Amphenol PCD

Engineering Change Request		ECR Number	R4986W
Initiator:	LEON	Date:	2021.01.20
Review by supervisor:	<i>Seibao</i>	Date:	2021.01.21

Item	K3 Code (Pls list all part numbers)	Drawing Number	Old revision	New revision
1	N/A	C-HVBI705R10XFCXXXFGXXL0000	E	F
2	N/A	C-HVBI705R10XFCXXXFGXXL0000C	B	C
3	N/A	C-HVBI705R10XFCXXXPCXXL0000	A	B
4	N/A	C-HVBI905R10XFCXXXFGXXL0000	B	C
5	N/A	C-HVBI905R10XFCXXXFGXXL0000C	1	2
6	N/A	C-HVBI905R10XFCXXXPCXXL0000	A	B

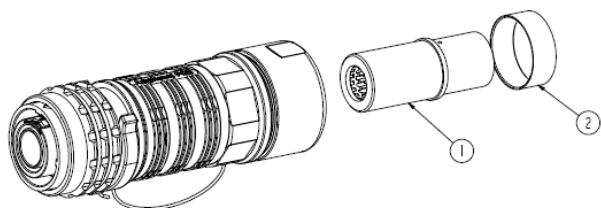
- Added a letter view to the drawing.
- Updated the technical parameters.
- Add the part view and the corresponding part number.

After change

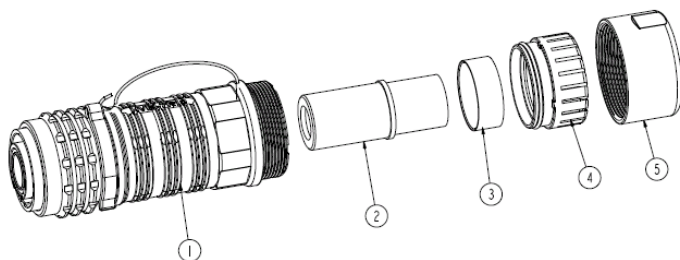
5A @ AMBIENT 70°C	+	⚠
1000V DC	+	
-40~125°C		
POWER CONTACT: 3000V AC(RMS)	+	⚠
HVIL CONTACT: 660 AC(RMS)	+	⚠
2000MΩ MIN. 25°C, NO CABLE	+	⚠

After change

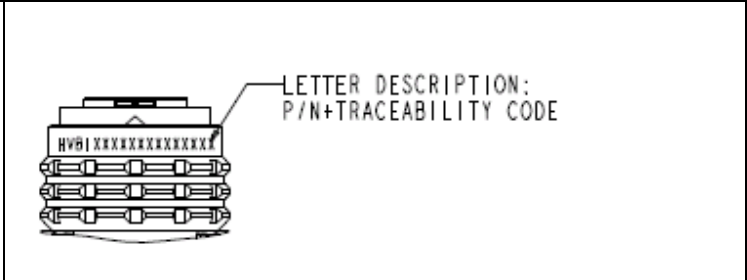
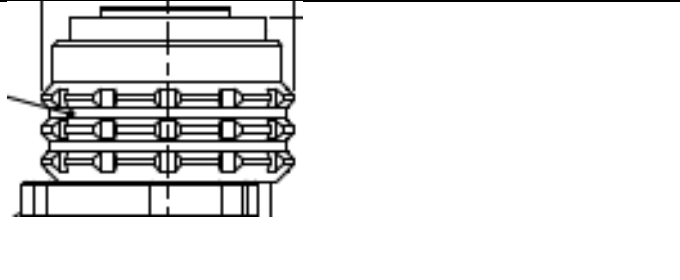
5A @ AMBIENT 70°C	+	△
1000V DC	+	
-40~125°C		
POWER CONTACT: 3000V AC(RMS)	+	△
HVIL CONTACT: 660V AC(RMS)	+	△
200MΩ MIN. 25°C, NO CABLE	+	△
